MONTGOMERY COUNTY PLANNING DEPARTMENT
 THE MARYLAND-NATIONAL CAPITAL PARK AND PLANNING COMMISSION

MEMORANDUM

REVIEW TYPE: Preliminary Plan of Subdivision; Resubdivision

PROJECT NAME: Clewerwall
CASE #: 120100150
REVIEW BASIS: Chapter 50, Montgomery County Subdivision Regulations

Figure 3: Preliminary Plan

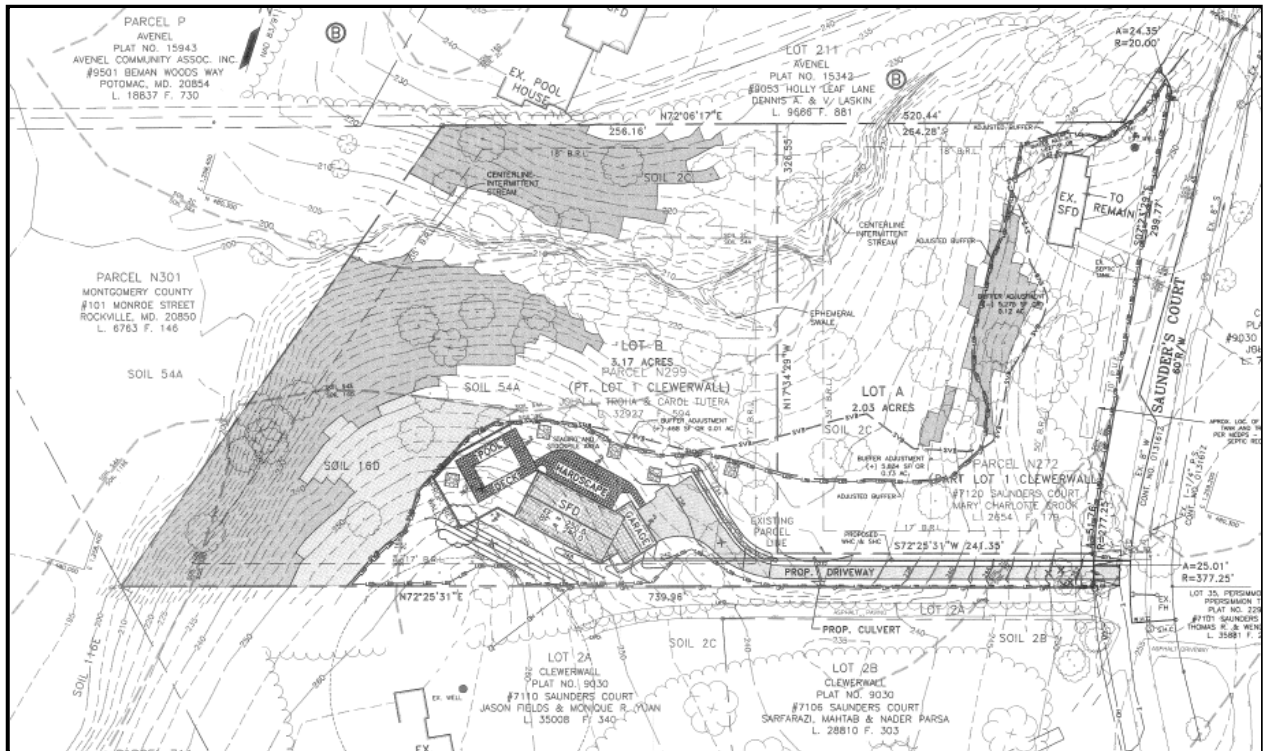
The Applicant proposes to create 2 lots from the two parts of lots, which constitutes a resubdivision. The current configuration of N272 and N299, as shown in Figure 1, is very similar to the proposed lot lines as shown in Figure 2. Proposed Lot A will be 2.03 acres in size and proposed Lot B will be 3.17 acres in size. Lot B will be a pipestem configuration that will mirror the adjacent two lots to the south, Lot 2A and 2B.

The existing house will remain on Lot A. Both lots will have private driveway access from Saunders Court. The house on proposed Lot A will continue to use its private well and septic system; Lot B will be provided public water and sewer house connections and a public utility easement has been provided to accommodate any necessary installation of utilities.

Figure 4- Encroachment Area

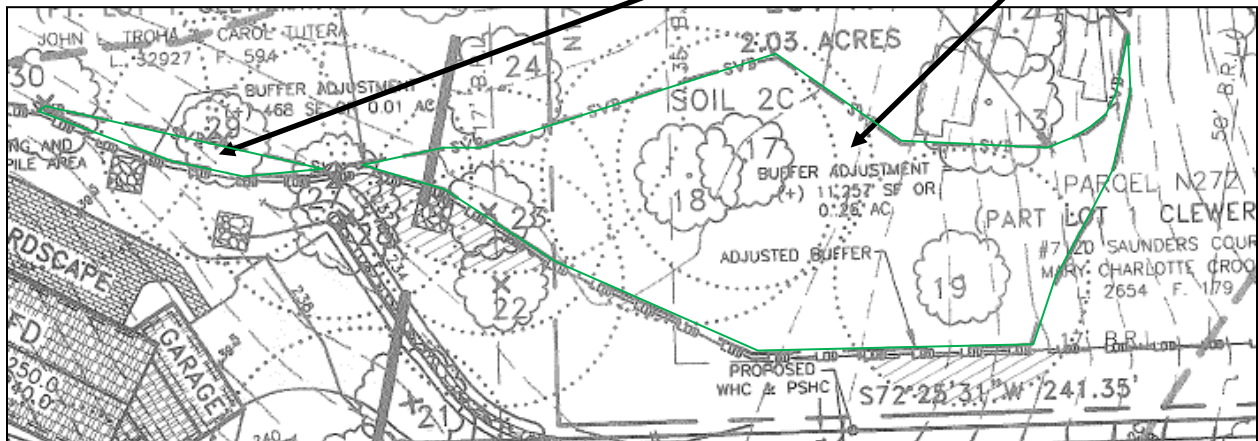
The forest conservation plan and preliminary plan shows 5,840 square feet of buffer encroachment. (See Figures 4 and 5) A typical request for encroachment would be to allow actual land disturbing activities within the delineated buffer, however; there is no grading or land clearing activity proposed within the encroachment area in this instance. This request is simply to exclude an area 35 feet from the back and side of the existing house from the restriction of a Category I easement so that the home may have a usable backyard and side yard free of restrictions. It will also allow for the existing modest home to be expanded or to be replaced with a larger home at a later time. Without permitting a modification to the buffer, there would be very little usable yard space around the house for active play, sheds, or gardens. Staff also notes that if the easement were placed on the delineated buffer line, it would significantly increase the likelihood of forest conservation easement violations. Staff believes that because of the current location of the house on proposed Lot A, it is appropriate to consider buffer averaging to eliminate these issues.

The requested encroachment area does contain a small area of steep slopes and forest, but it does not include any wetlands, rare threatened and endangered species habitat, or any state mandated buffers. The applicant is proposing to mitigate the 5,840 square feet of buffer encroachment by placing 11,725 square feet of land that currently lies outside but is abutting to the delineated stream buffer in a Category I conservation easement. The compensation area is forested and adjacent to the delineated buffer and exhibits many of the same characteristics of buffer area. This proposed mitigation is slightly greater than a 2:1 ratio.

Areas to be excluded from Category I easement totaling 5,840 s.f.

Areas to be included in Category I easement totaling 11,725 s.f.

From an environmental perspective, the forest resource in the compensation area is of equal or greater value than what might have been protected in the delineated buffer simply given the size of the compensation area and the forest resource within it. The mitigation offset is consistent with the overall goal of protecting environmental resources. After reviewing the plan

and considering the five factors above, staff believes the applicant's proposal is consistent with a comprehensive approach to protecting environmentally sensitive areas while providing flexibility for the existing uses. Staff recommends that buffer averaging be accepted and approved as part of the preliminary forest conservation plan and that the buffer shown on the preliminary forest conservation plan be placed in a Category I conservation easement and shown on the record plat.

Figure 6: Resubdivision Neighborhood Map

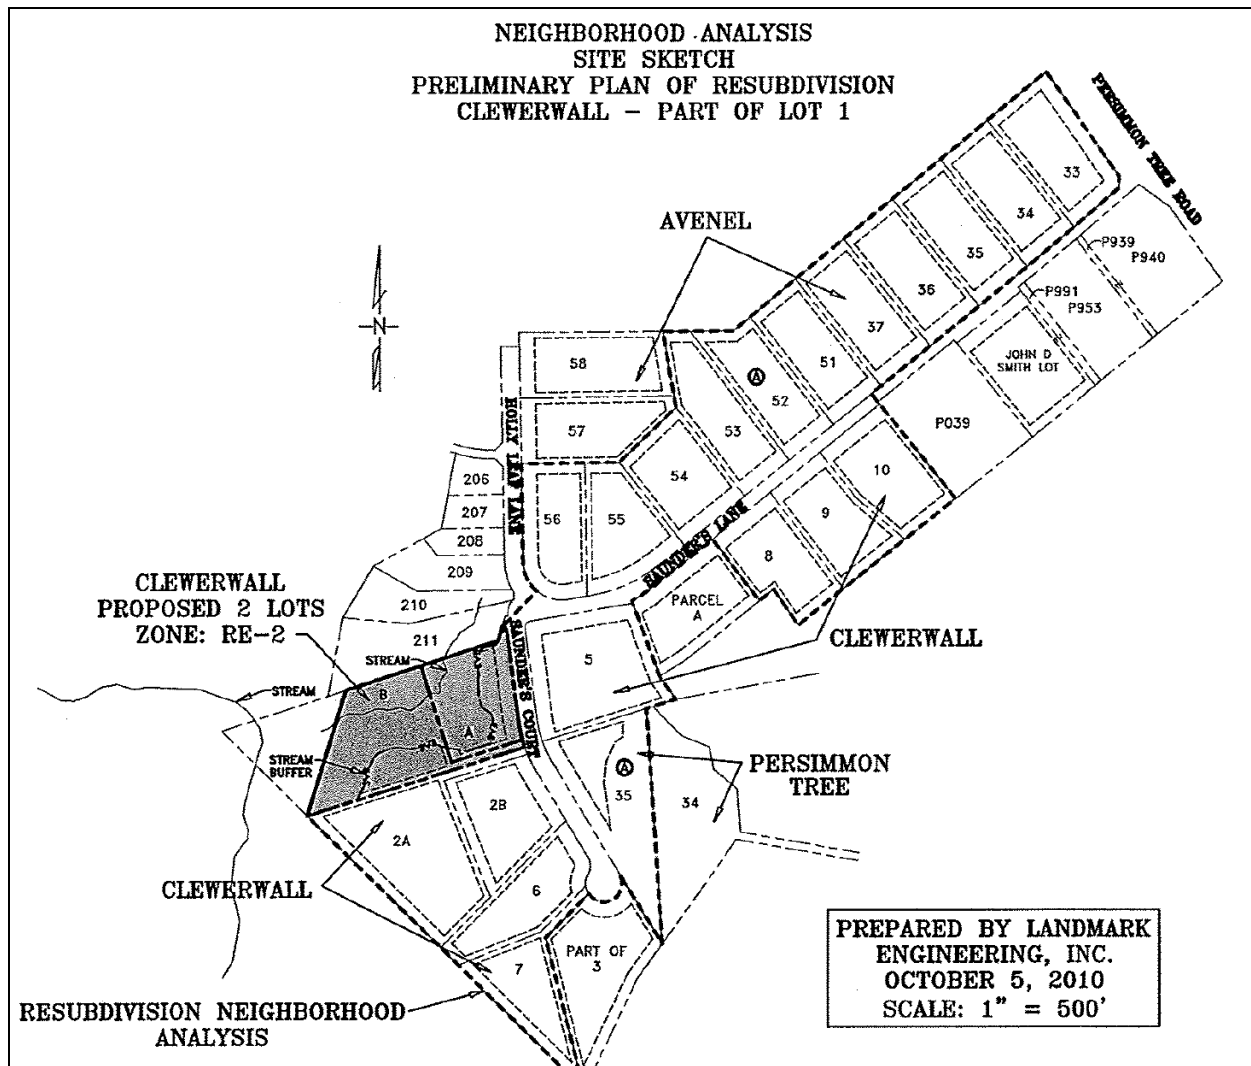
In administering Section 50-29(b)(2) of the Subdivision Regulations, the Planning Board must determine the appropriate “Neighborhood” for evaluating the application. In this instance, the Neighborhood agreed upon by staff and the Applicant consists of 20 lots. The Neighborhood is depicted in Figure 6 on the following page. The Neighborhood includes all lots that abut Saunders Lane and Saunders Court. Even though the lots on the north side of Saunders Lane are zoned RE-2/TDR, those that physically front on Saunders Lane were platted under the RE-2 zone standard method and are, therefore, appropriate for inclusion in this resubdivision Neighborhood because they developed under the same method as the Subject Property. As is staff and Board practice, unplatted parcels are not included in the Neighborhood. The designated Neighborhood provides an adequate sample of the lot and development pattern of the area. A tabular summary of the area based on the resubdivision criteria is included in the data table in Figure 7 below.
